The ISO received comments on the topics discussed at the November 18, 2019 stakeholder meeting from the following:

The following are the ISO's responses to the comments.

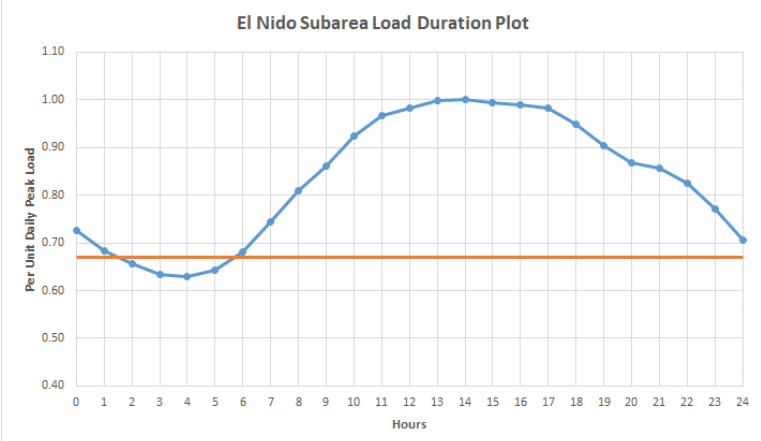
2c	<p><u>Need to Utilize Dynamic Transmission Rating Methodology</u> The CAISO's transmission planning analysis assumes the summer emergency ratings that presumably correspond to the traditional summer peak hour, that is, HE16. However, as the Summer peak hour is expected to shift to HE 18 or HE19 in the future, it would be appropriate to update (increase) the transmission line ratings accordingly. It appears that by modeling the traditional summer peak temperature rating, the CAISO might be underestimating transmission line capacity and in turn, the local area import capabilities. BAMx recommends that the CAISO start a stakeholder process where the Participating Transmission Owners (PTOs) can explain proposals they may have for taking this shift (in the timing of maximum stress on the transmission system) into account in their line rating process. Although we would expect some circumstances might lead to different rating methodologies among PTOs, it would be very informative to have a single stakeholder process to allow comments on the proposed methodologies.</p> <p>Furthermore, from an operational standpoint, the CAISO needs to consider utilizing dynamic ratings. The import capability envisioned in the LCR reduction studies is assumed to be the same throughout the day because the CAISO assumes the circuits are rated the same throughout the day. However, if the CAISO were to adopt dynamic ratings as done by PJM10, the night hours would have a higher rating for transmission lines and transformers than the daytime ones since the transmission elements would not be heated due to solar radiation. This more appropriate approach would provide greater imports and</p>	<p>The ISO applies the Facility Ratings as determined and provided by the transmission owners for their transmission facilities. Further to this, with respect to transmission lines in the PG&E area that have been rerate based upon 4 ft/s wind speeds (increased from 2 ft/s) the higher rating is only applicable from 10 am to 7 pm. The ISO will continue to assess this in future planning cycles.</p>
